10/801,343

Office Action Summary	Application No. 10/801,343	Applicant(s) BIANCO, MICHAEL	
	Examiner Tho v. Duong	Art Unit 3744

DETAILED ACTION

Figure A: the modified figure corresponds to figure 2 with air plenum shown

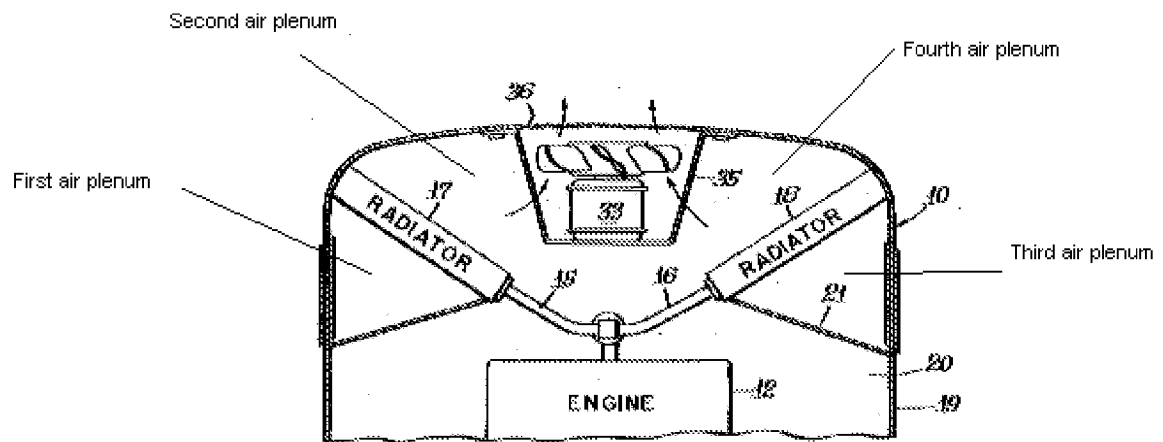
Claims 27-35 and 49-55 are rejected under 35 U.S.C. 102(b) as being anticipated by H. L. Myrent et al. (US 2,756,026). Myrent discloses (figures 1-2 and A bellow) a system for transporting produce comprising a container (vehicle) and a heat exchanger associated with the container; the heat exchanger comprising a housing (on the left side of figure 2) adapted to enclose a coil assembly (17), the coil assembly tilted in an interior of the housing, the coil assembly partially defining in the housing on opposite sides of the coil assembly a first airflow plenum and a second airflow plenum; at least one air mover (33) situated adjacent to the housing, the air mover (33) configured to draw airflow through the second airflow plenum in a first generally horizontal direction, the air mover (33 directing the airflow from the second airflow plenum in a second generally vertical direction substantially to the first generally horizontal direction; the heat exchanger further includes another housing (on the right side of figure 2) configured to enclose another coil assembly (18), the other coil assembly tilted in another interior of the other housing, the other coil assembly partially defining in the other housing on opposite sides of the other coil assembly (18) by a third airflow plenum and a fourth airflow plenum and the other housing is situated on an opposite side of the air mover (33) from the housing, the air mover (33) configured to draw airflow through the fourth airflow plenum in a

third direction, the at least one air mover directing the airflow from the fourth airflow plenum in the second generally vertically direction; the system further comprises a further heat exchanger (engine) associated with the container. The heat exchanger is situated within the vehicle and on the top side of the vehicle. The vehicle is capable of transporting all kind of produce including marine or fresh produce.
